RESOLUTION NO. R-4148

A RESOLUTION OF THE CITY OF KIRKLAND APPROVING THE ISSUANCE OF A PROCESS IIA PERMIT AS APPLIED FOR IN DEPARTMENT OF PLANNING AND COMMUNITY DEVELOPMENT FILE NO. IIA-97-76 BY RETAIL PETROLEUM MARKETING (HAMID NOURI) BEING WITHIN A BC ZONE, AND SETTING FORTH CONDITIONS TO WHICH SUCH PROCESS IIA PERMIT SHALL BE SUBJECT.

Conditions No. 2, 3, 7 and 8 of the Hearing Examiner decision of File IIA-97-76 shall be modified and replaced with the following conditions:

ATTACHMENT A
 R-4841

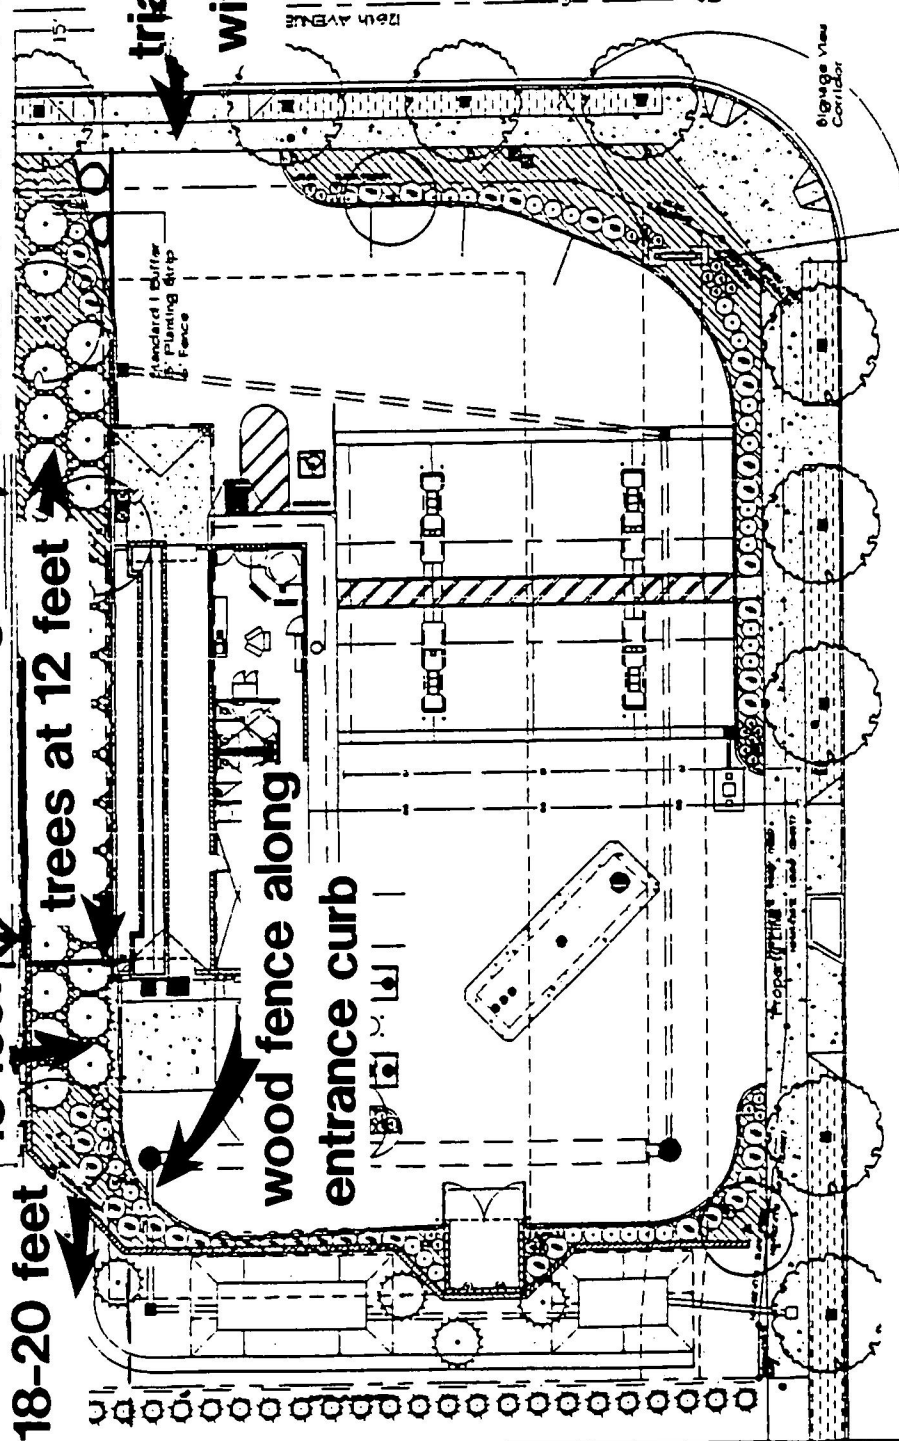
7. Landscaping and Fencing –
 - a. With the building permit submittal, the applicant shall show on the landscape and site plans the following (see Attachment A, revised site plan):

- 1) A continuous 15 foot wide landscape buffer along the entire north property line, including north of the driveway on the east side of the site, shall be installed.

- 2) A six foot high decorative, concrete sound fence wall shall be installed on top of the retaining wall from the west side of Fred Naslund's house to the southern end of the vacuuming area on the west side of the site. Between 126th Ave NE and the west side of Mr. Naslund's house where there is no proposed retaining wall, the top of the six foot high concrete fence shall be at an elevation of 367 feet. The retaining wall shall be extended to the east, if necessary, with the concrete fence on top of the extended retaining wall to achieve a top of fence elevation of 367 feet.

- 5) Two rows of evergreen trees shall be planted eight feet on center in the entire buffer.

- 6) For the portion of the buffer adjacent to Mr. Naslund's property directly to the north, all newly planted trees shall be 12 feet in height at the time of planting and of a type of evergreen tree that shall not exceed 30 feet in height at maturity so as to maintain solar access to the lots to the north. The applicant shall submit to the Planning Department written information from a landscaping company or nursery that the trees will not exceed 30 feet in height at maturity.

- 7) For the portion of the buffer adjacent to Mr. Johnson's property to the north, all newly planted trees on top of the retaining wall shall be 15 feet in height at the time of planting. In the northwest corner where there is no retaining wall, the trees shall be 18 to 20 feet at the time of planting. There is no limit on how tall these trees may reach at maturity.

- 8) A solid wood fence shall be erected along the west curb of the driveway entrance into the car wash. The finished side of the fence shall face towards Mr. Johnson's property. The applicant shall state on the site plan for the building permit submittal that "the final height and length of the fence shall be determined in the field at a meeting with the applicant, Neil Johnson and the Planning Department prior to occupancy. The required height and length of the fence shall be based on the needed height and length to block Mr. Johnson's view of the car wash entrance on the west side from his second floor living room."

- b. To prevent exiting customers from turning northbound onto 126th Ave NE around the triangular curb, the eastern triangular curb shall have a south curb extension and the exiting lane shall be narrowed to sharpen the turning radii.

trees at 18-20 feet
 trees at 15 feet
 fence on top
 of retaining
 trees at 12 feet

sound fence at elevation 367

triangular curb
 with extension

wood fence along
 entrance curb
